COUNTY OF SAN MATEO
RECONSTRUCTION OF SEVENTH AVENUE FROM MIDDLEFIELD ROAD
TO EDISON WAY IN THE NORTH FAIR OAKS AREA
COUNTY ROAD NUMBER 561-A

COUNTY PROJECT NO. RW703
PROJECT FILE NO. E4957000

ADDENDUM NO. 2

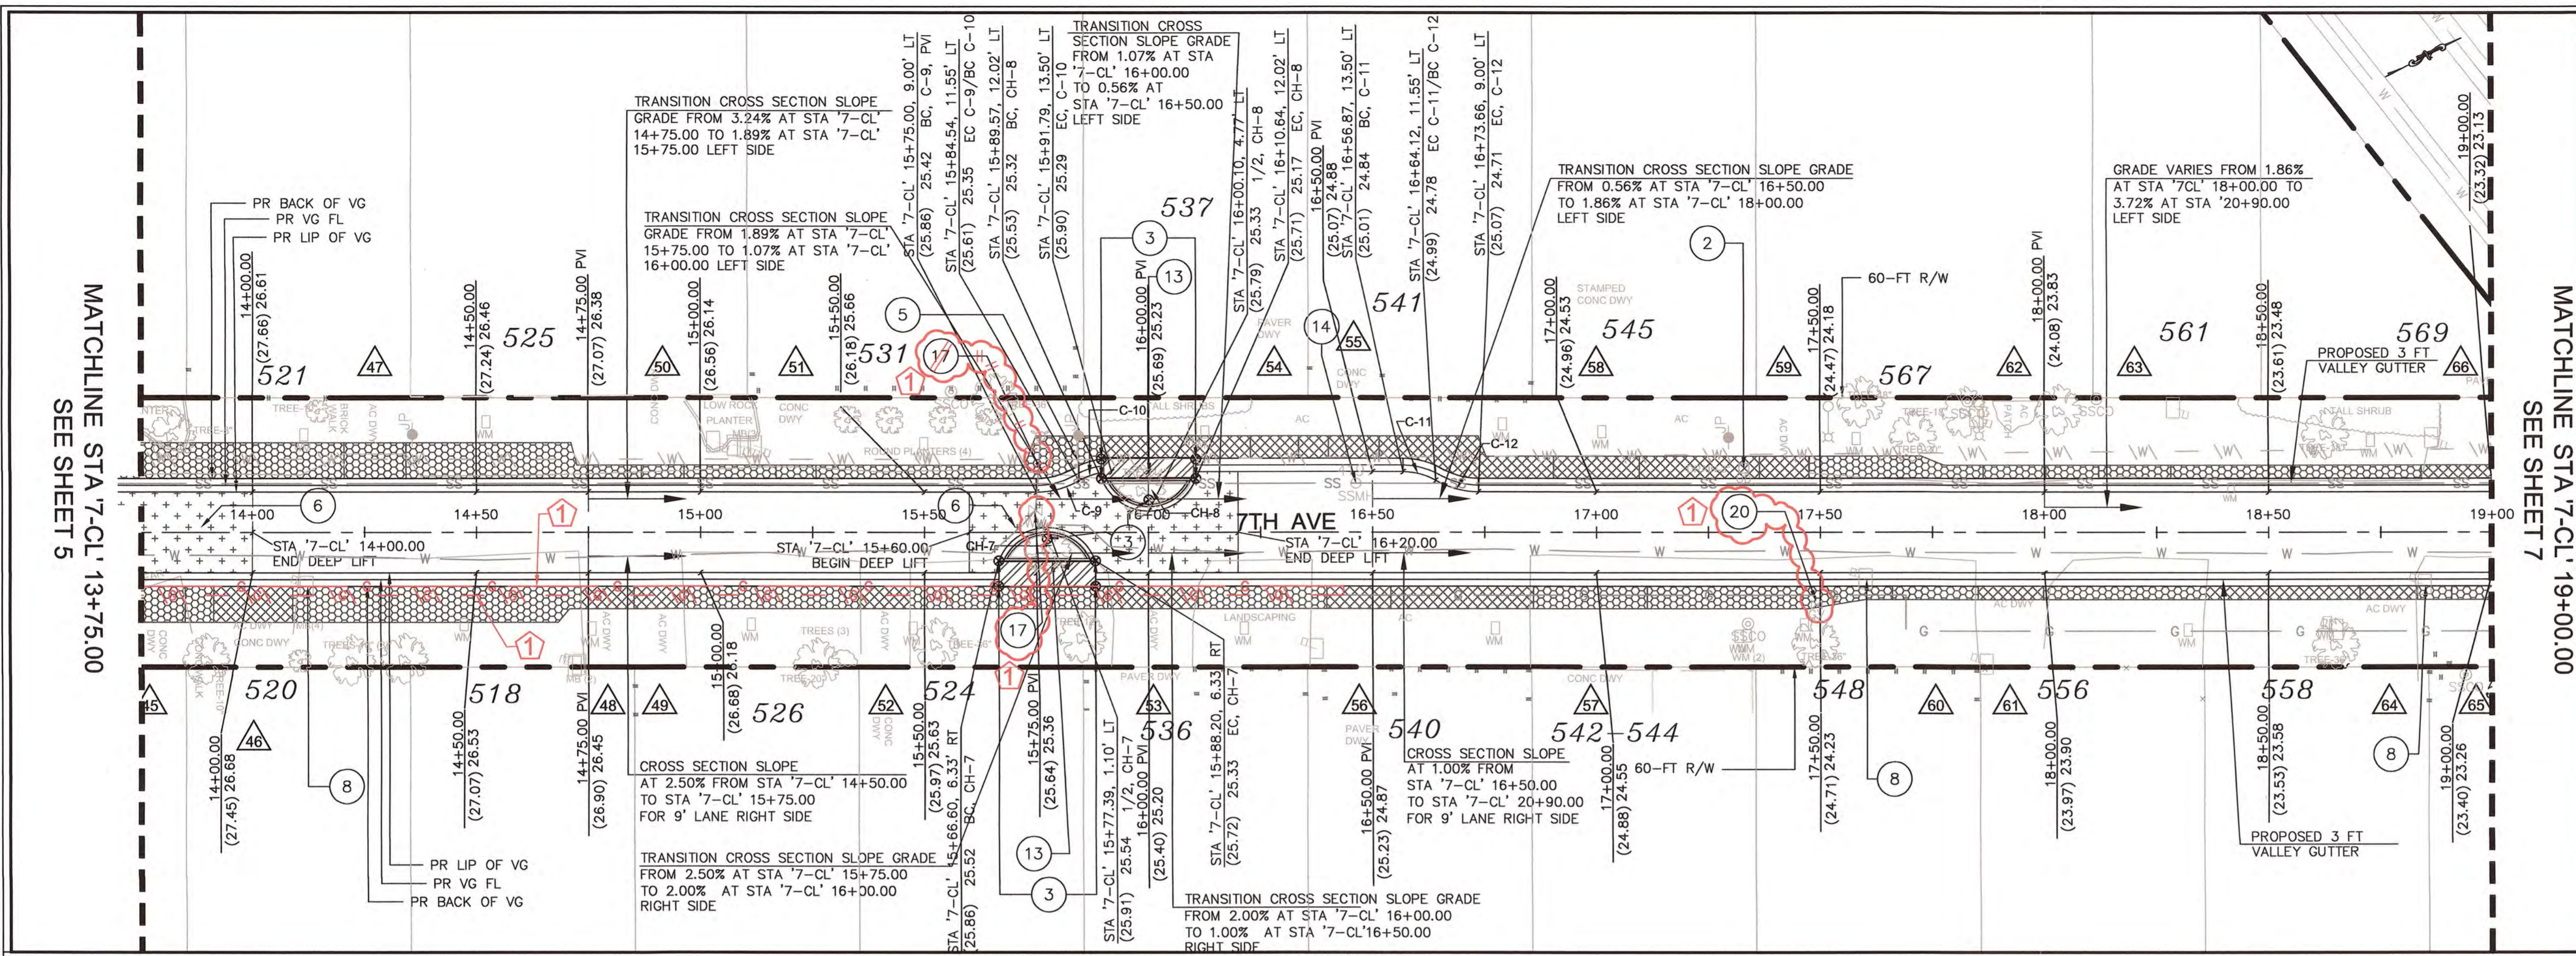
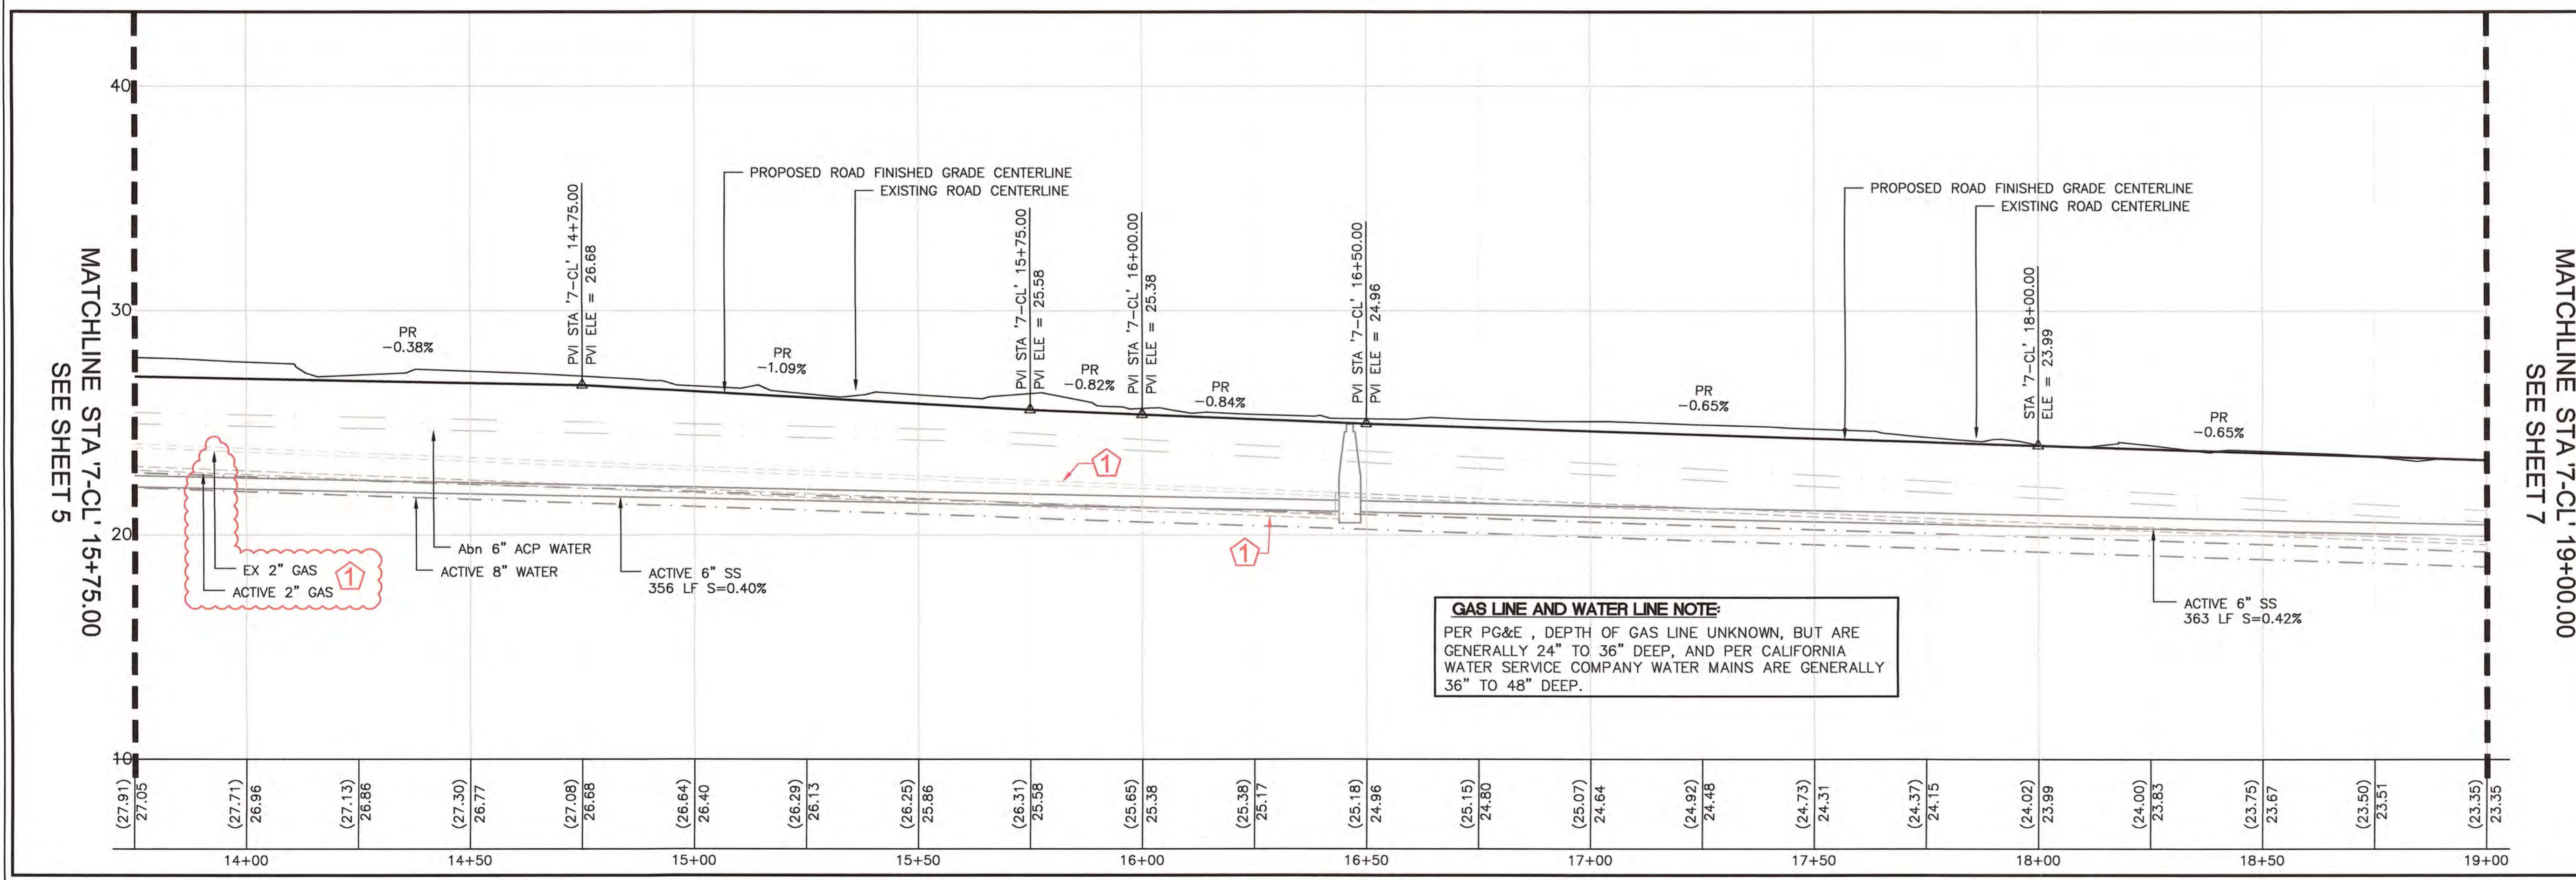
UPDATES:
 1.) HATCH PATTERNS DARKNESS ADJUSTED TO MATCH THE PLAN AND LEGEND
 2.) "ASPHALT CONCRETE" LABEL CHANGED TO "MISCELLANEOUS ASPHALT CONCRETE" LABEL
